Project Name: Wayne State University
Football Stadium Elevator
Adams Field
Detroit, Michigan

Addendum Number: 4

Date: 1/2/2020

Addendum Number: 4

THE FOLLOWING DIMENSION EQUALS
ONE INCH WHEN PRINTED TO SCALE.

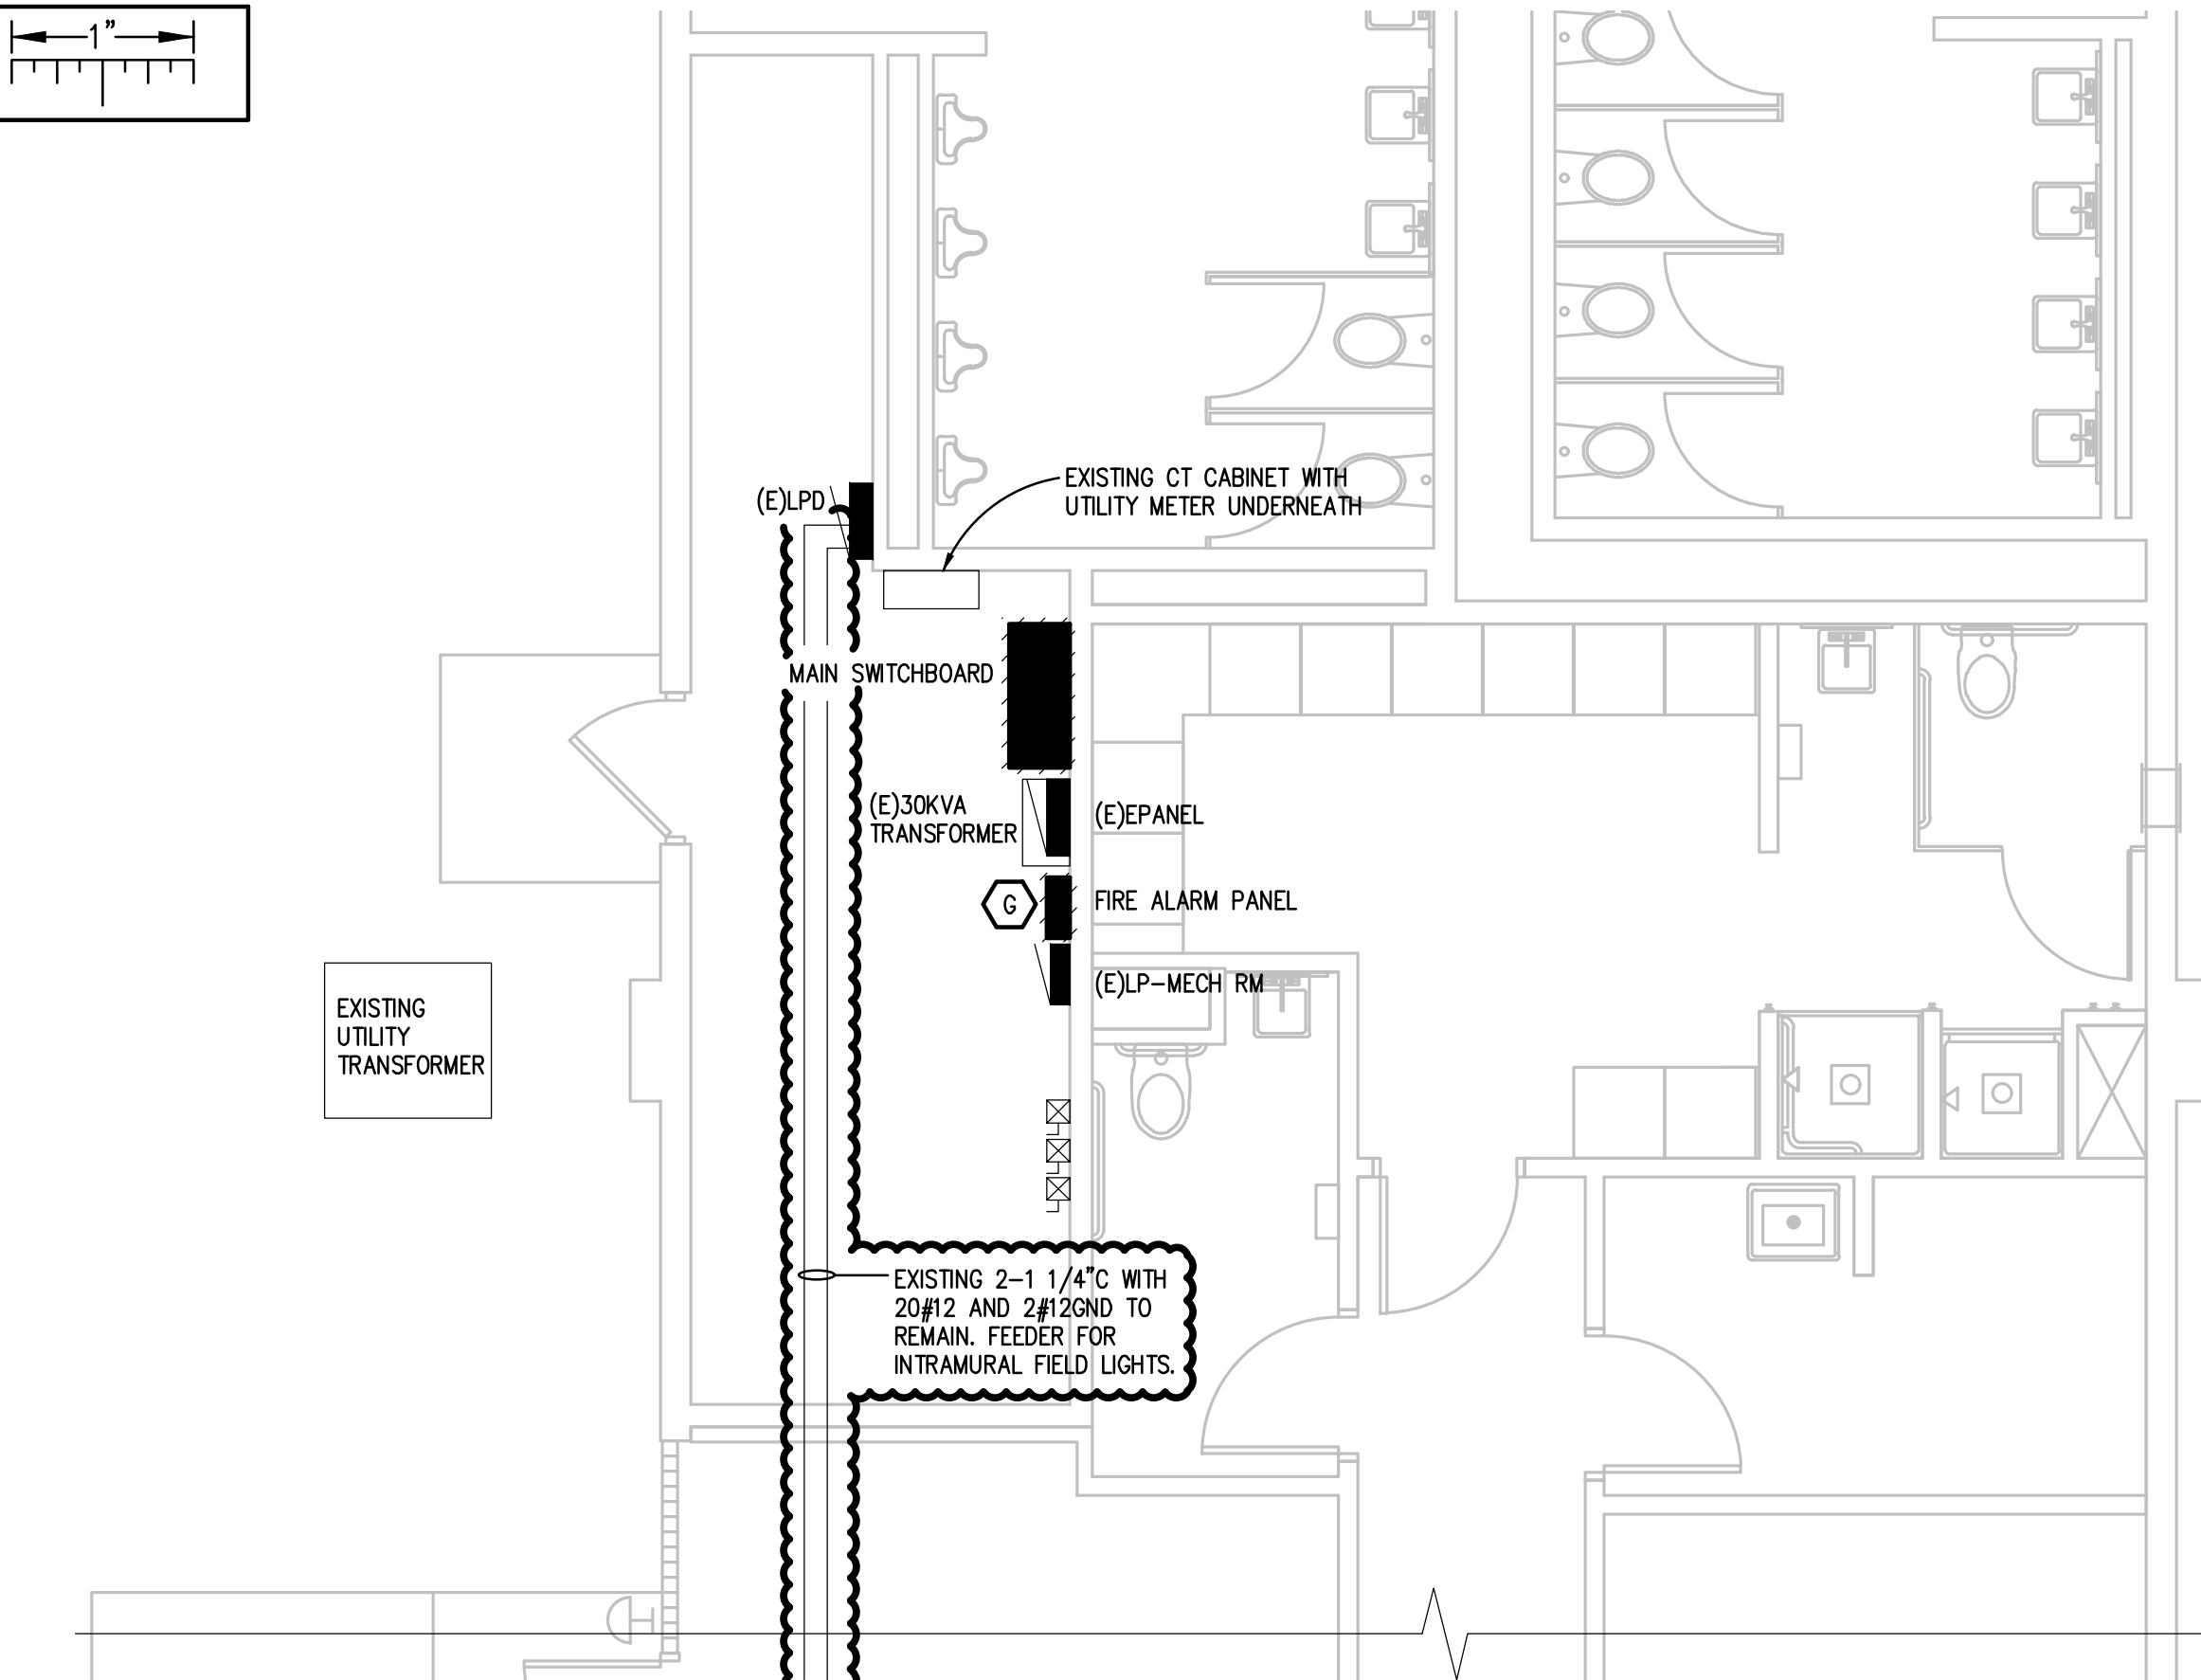
1. Added NEMA 3R box as indicated.
2. Added conduit as indicated.

SHEET
ED.11

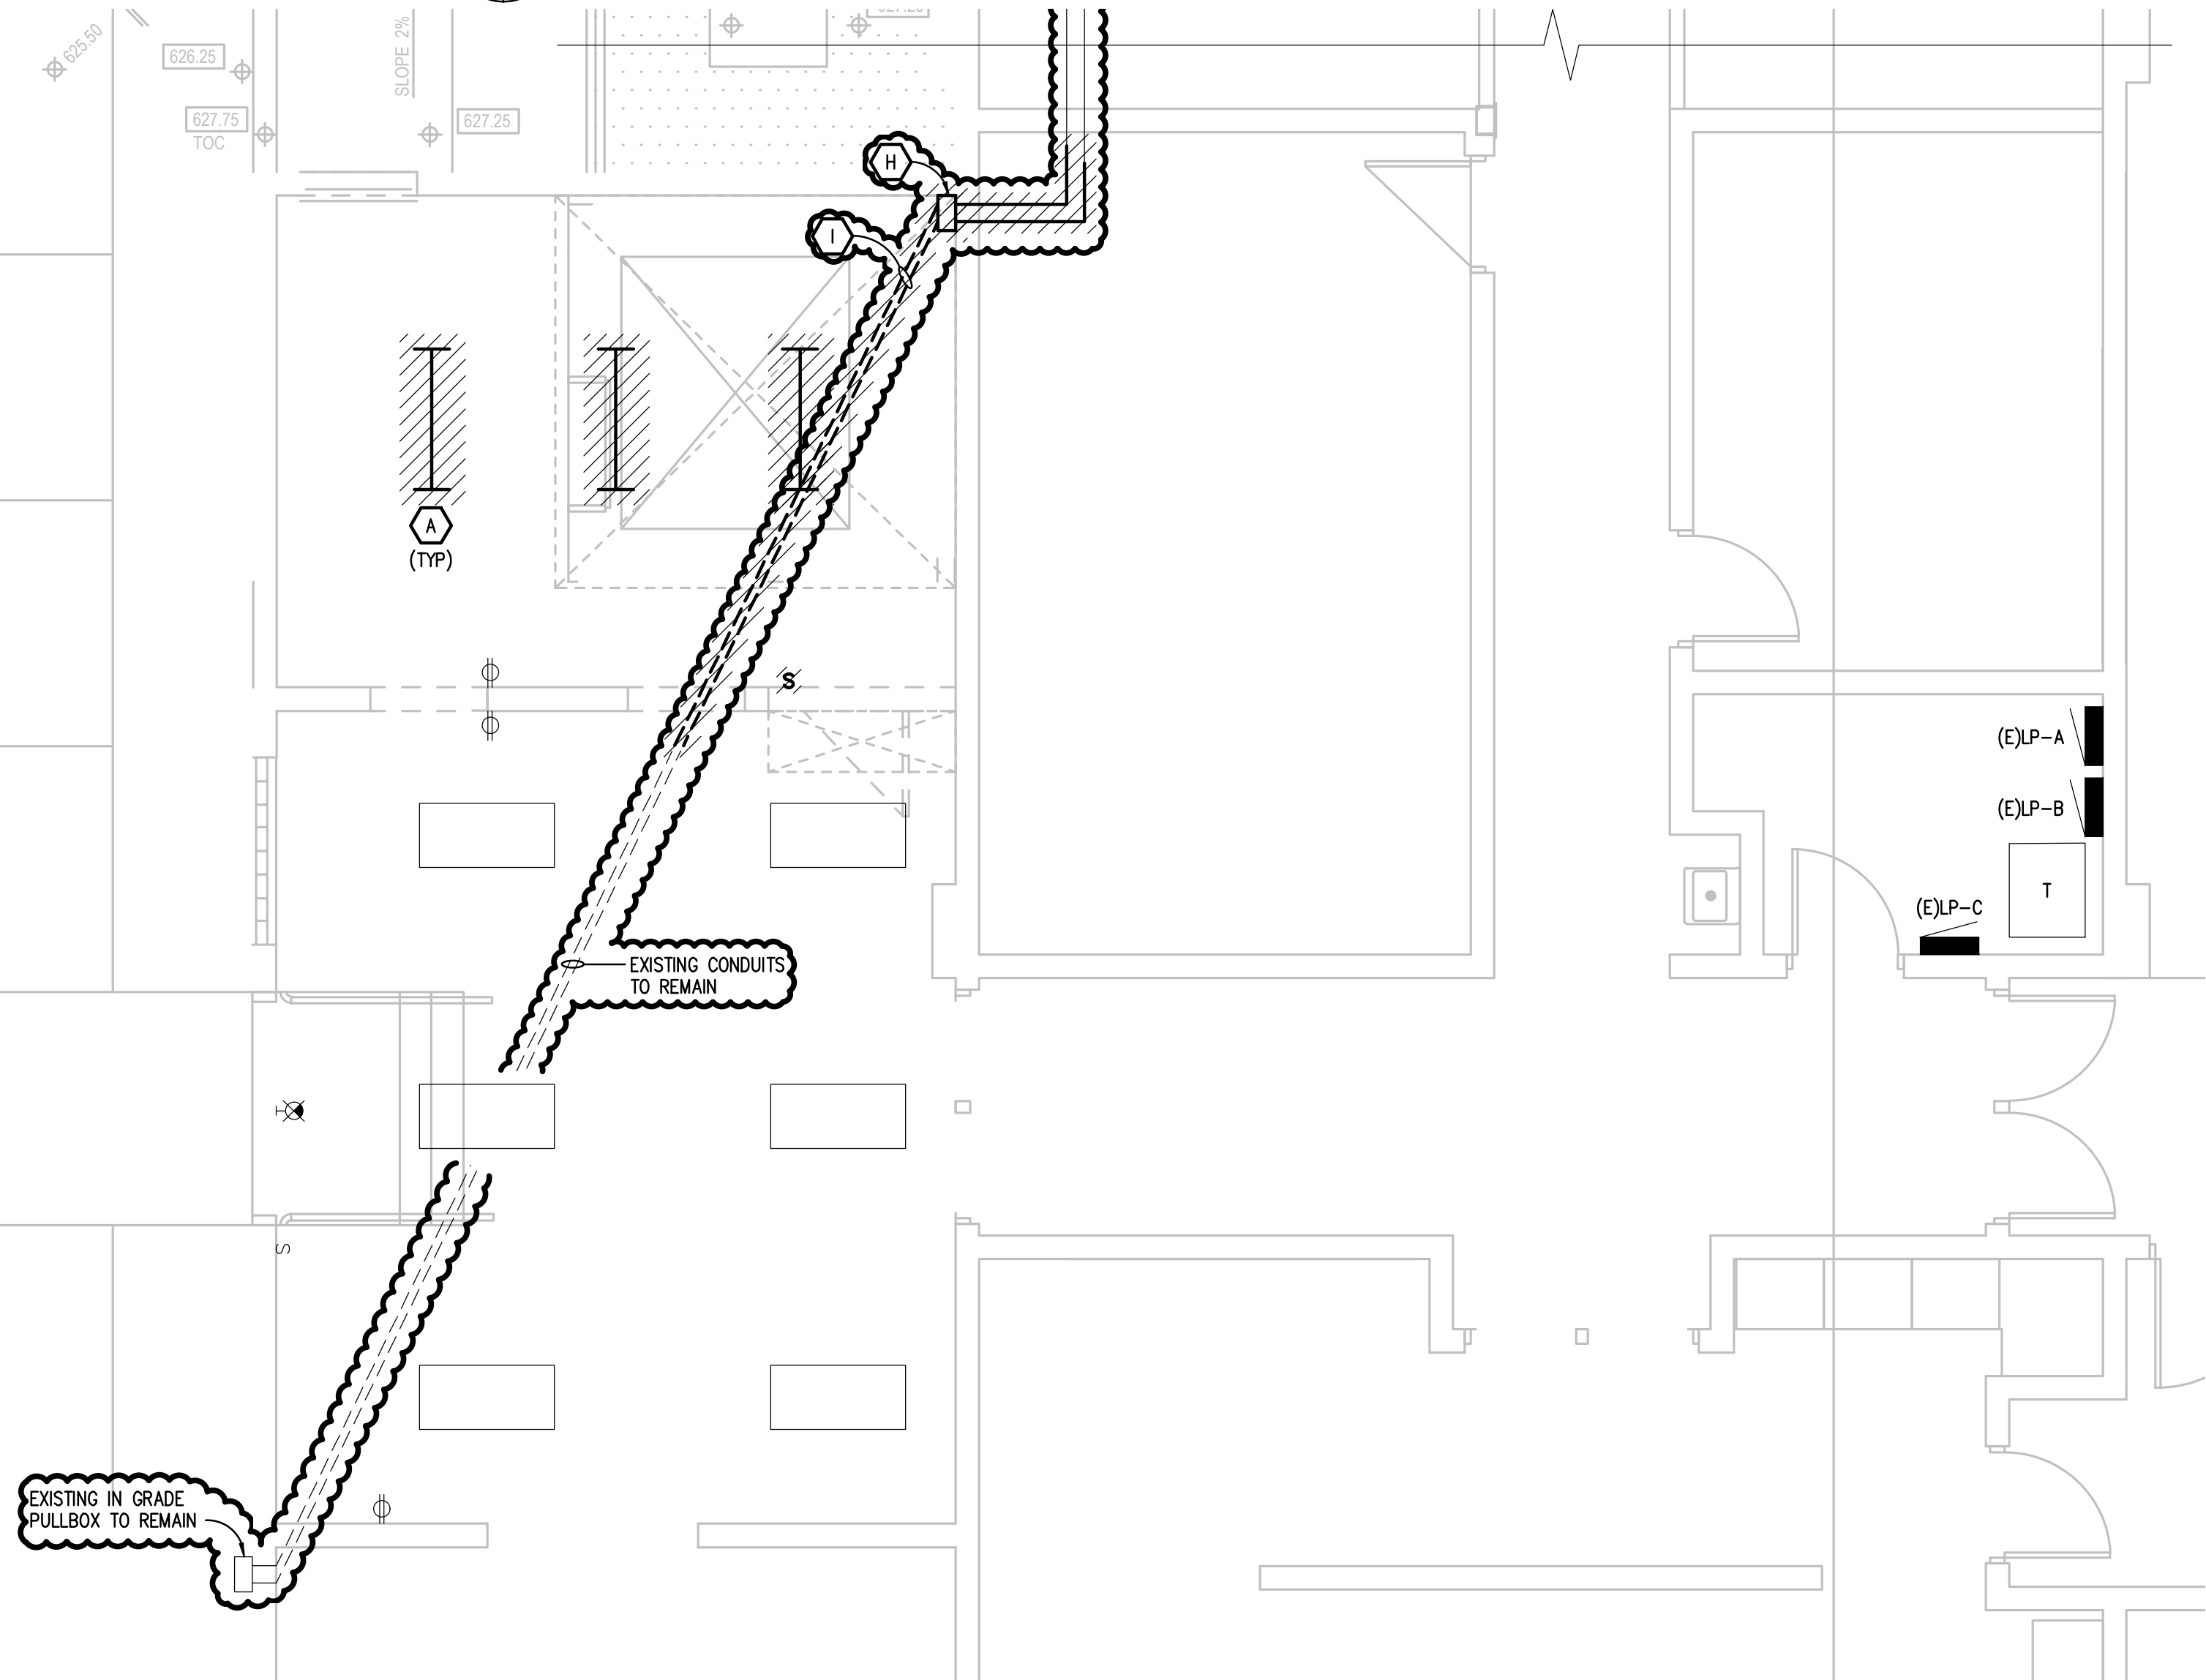
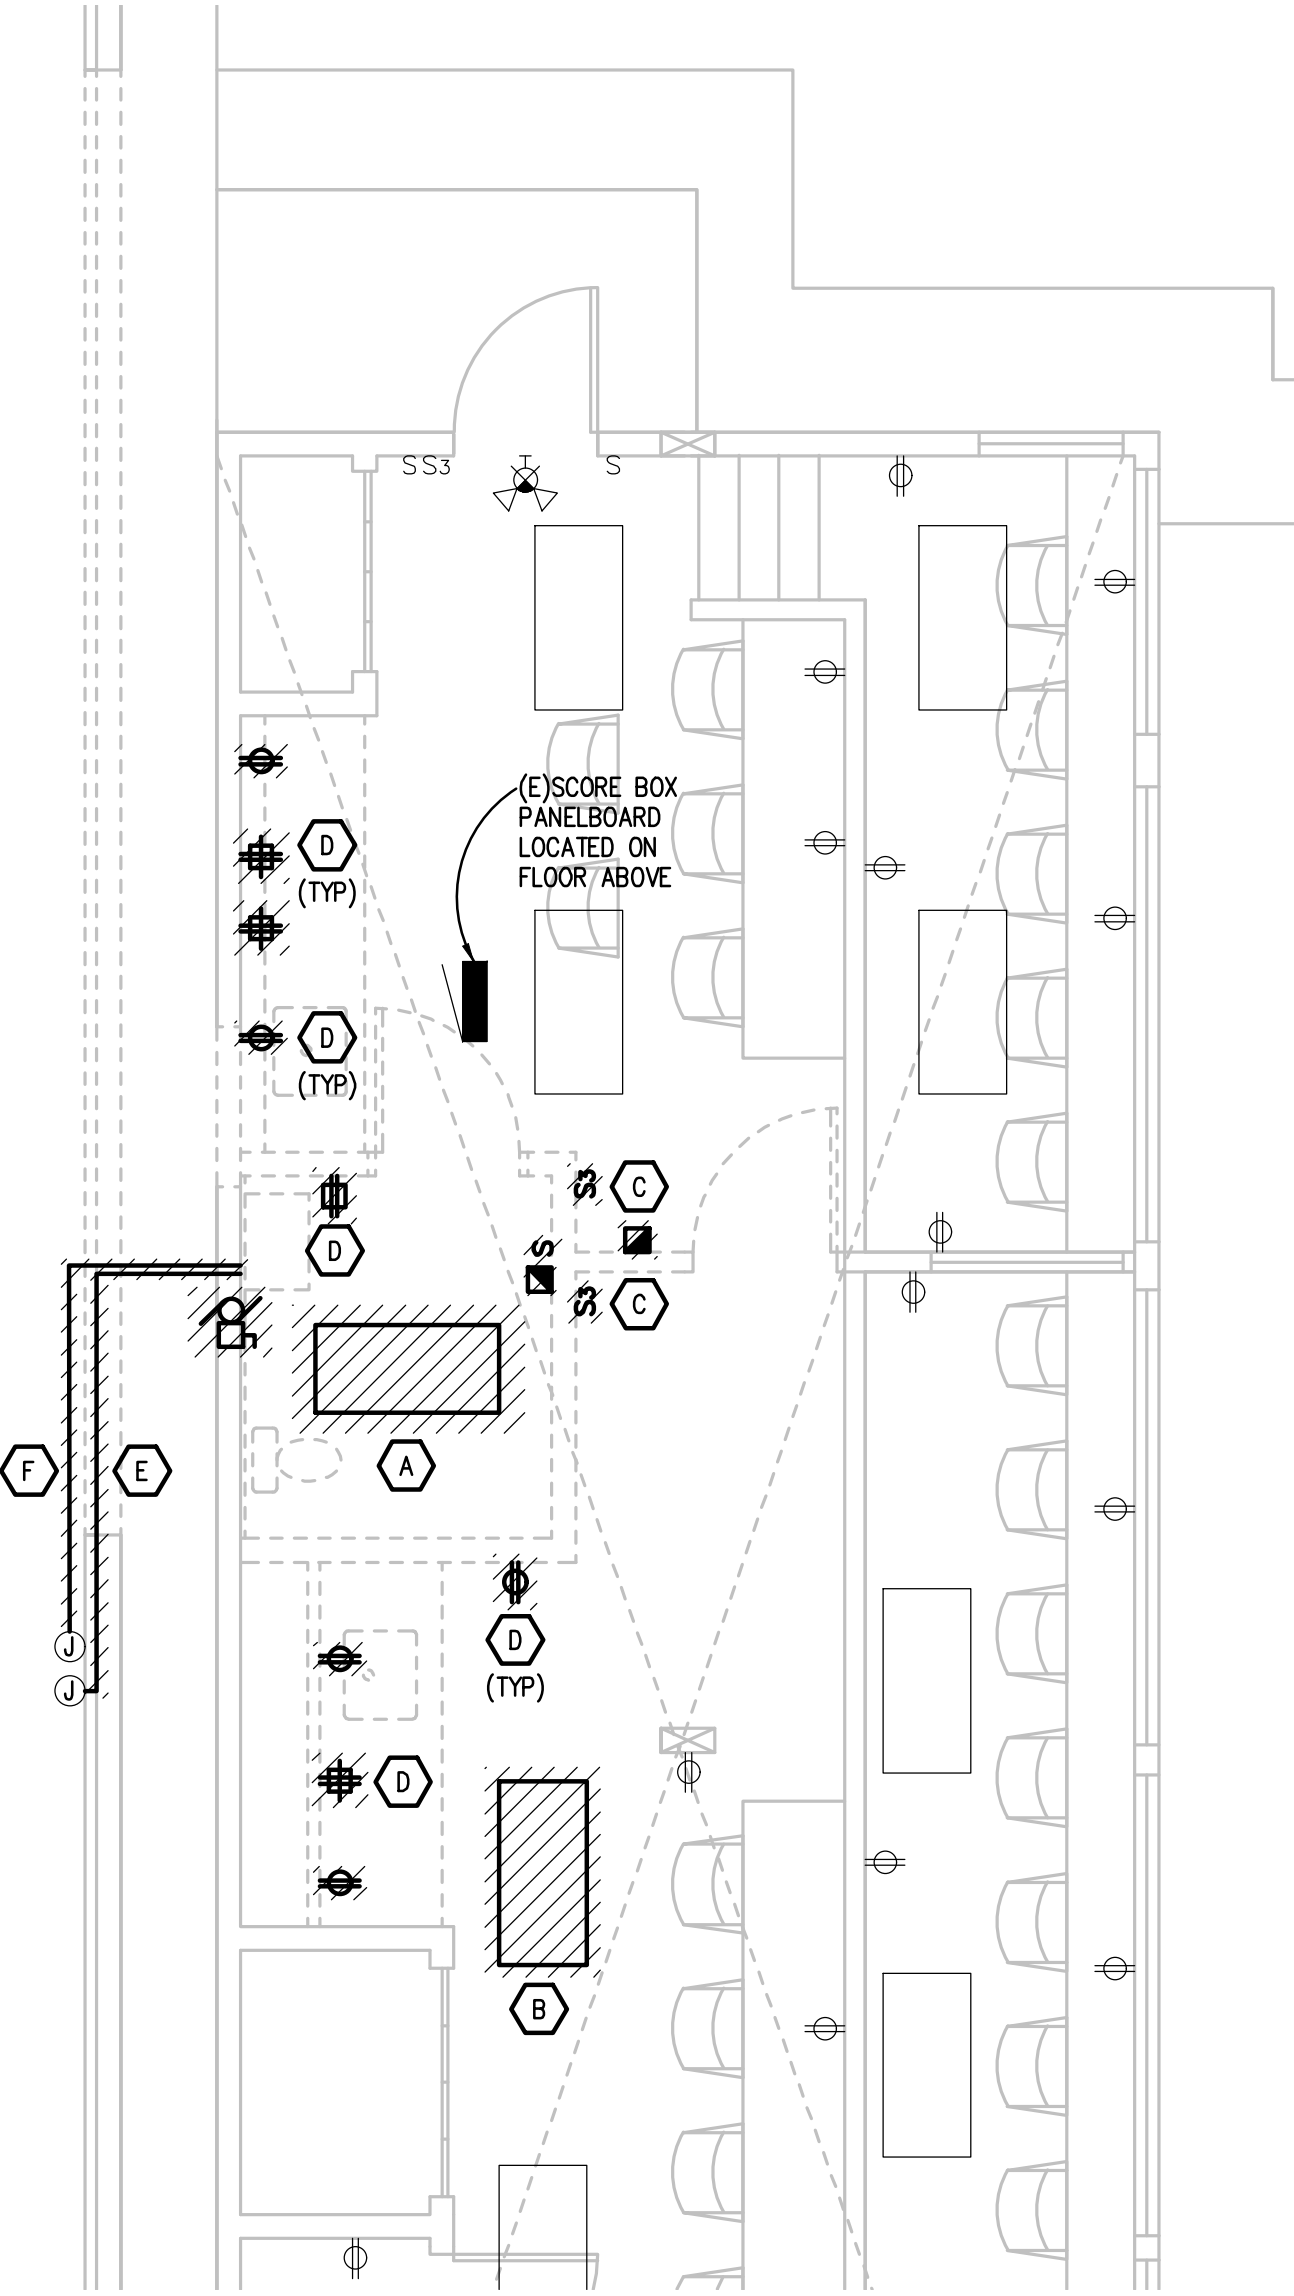
1. Added existing conduit as indicated.
2. Added pullbox as indicated.
3. Added handhole as indicated.
4. Added Demo notes H and I as indicated.
